**Written submission from the
Manitoba Métis Federation**

**Regulatory Oversight Report for
Uranium Mines, Mills, Historic and
Decommissioned Sites in Canada: 2023**

2023 Regulatory Oversight Report for Uranium Mines and Mills

Written Intervention

Figure 2. CSNC inspections (blue) and occurrence of non-compliance (orange) from 2019-2023.

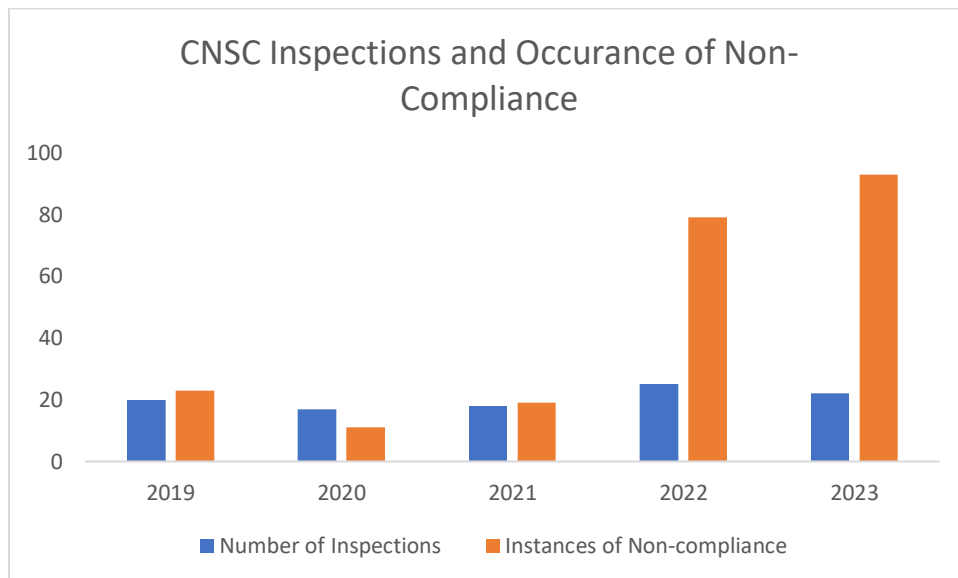
In 2023, all fourteen Safety Control Areas (SCAs) were found to be “Satisfactory”, which is the highest level of compliance a licensee can achieve within the ROR framework. However, the MMF is concerned regarding the apparent disconnect between the overall SCA evaluation and incidents of non-compliance observed at individual UMM facilities. Perhaps most notable is the significant increase in instances of non-compliance in 2022 (79 + 1 order) and 2023 (93 + 1 order) relative to previous years (average of 18 non-compliances per year from 2019-2021 and no orders issued; Figure 2).

As described throughout the ROR report, many of the non-compliances reported were identified as having a low risk to safety, however, the determination of what constitutes *low risk* is somewhat subjective. For example, as noted in Section 4.10 Emergency Management and Fire Protection, an inspection at the Rabbit Lake Operation resulted in an Inspector's Order. This was followed by the discovery that PPE used by the emergency response team had expired by between 3 and 10 years, and further, insufficient quantities of PPE were found on site.

The MMF recognizes that this issue is relatively easy to remedy, simply through the procurement of additional PPE, it appears to be a serious risk to the effectiveness of the emergency response team. The MMF questions the CNSC as to why this occurrence did not result in a downgrade of the SCA evaluation for Rabbit Lake and is further concerned that by evaluating this SCA as "satisfactory" the CNSC sends a message to licensees that seemingly minor non-compliances, even if they may have broad potential for adverse impacts is acceptable.

In providing an evaluation for SCAs in the ROR, the MMF recommends that the CNSC provide additional context for the evaluation criteria as well as facility-specific context for why the SCA was assigned the corresponding rating.
